# UNITED STATES PATENT AND TRADEMARK OFFICE

# Office Action Summary

10/781,194

## DETAILED ACTION

Figure 5 Noji et al. (US 557932)

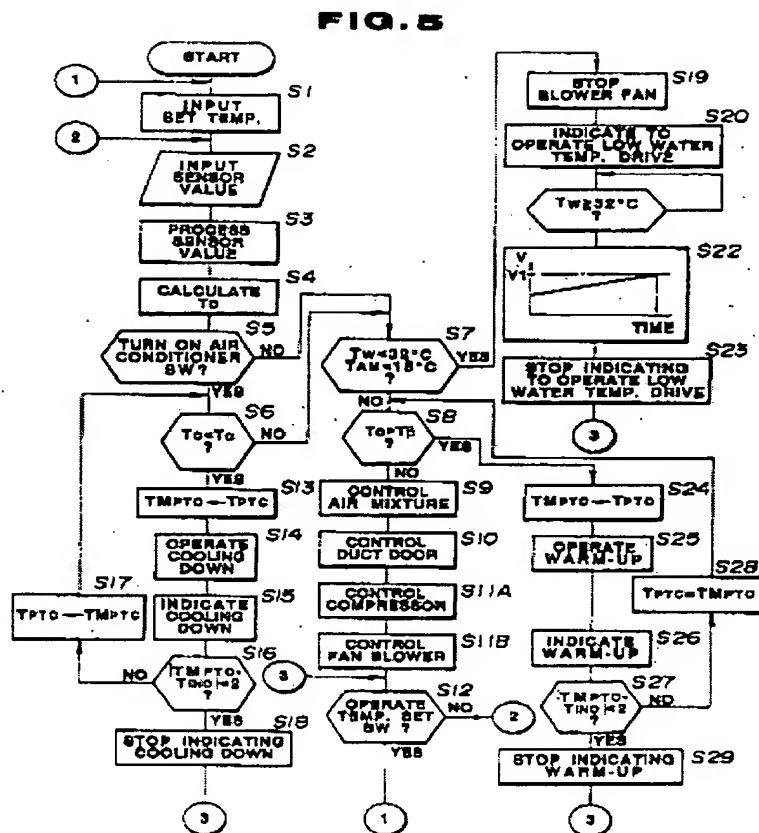
In regard to claim 19, Noji et al. teach a vehicle air conditioner with a passenger compartment temperature sensor 42, a control unit 31, and an environment condition detection means 43, which detects an amount of compartment solar radiation present (column 3 lines 35-40). The control unit generates airflow into the passenger compartment based on the temperature detected by the passenger compartment sensor and solar radiation sensor (column 4 lines 1-15, 52-57 and column 5 lines 22-25). Note the compartment temperature sensor and solar radiation sensor are used to calculate the target outlet temperature, and that the airflow rate is generated in accord with the target outlet temperature (column 4 lines 52-57). Noji et al. further teach a control algorithm, see Figure 5, used as a determining means for determining whether the compartment temperature sensor has detected an abnormal temperature; indicating the vehicle is too hot or too cold (column 3 lines 68-70 and columns 4 and 5 lines 1-65 respectively).

Noji et al. teach an abnormal temperature as an outlet temperature less than  $T_{\alpha}$  in step S6 or greater than  $T_{\beta}$  in step S8. Note that the compartment temperature sensor is used to calculate the target outlet temperature TAO (column 4 lines 1-12), and that the target outlet temperature is used to determine if the vehicle compartment is too hot (column 5 lines 1-10 and 26-32) or too cold (column 6 lines 1-13).
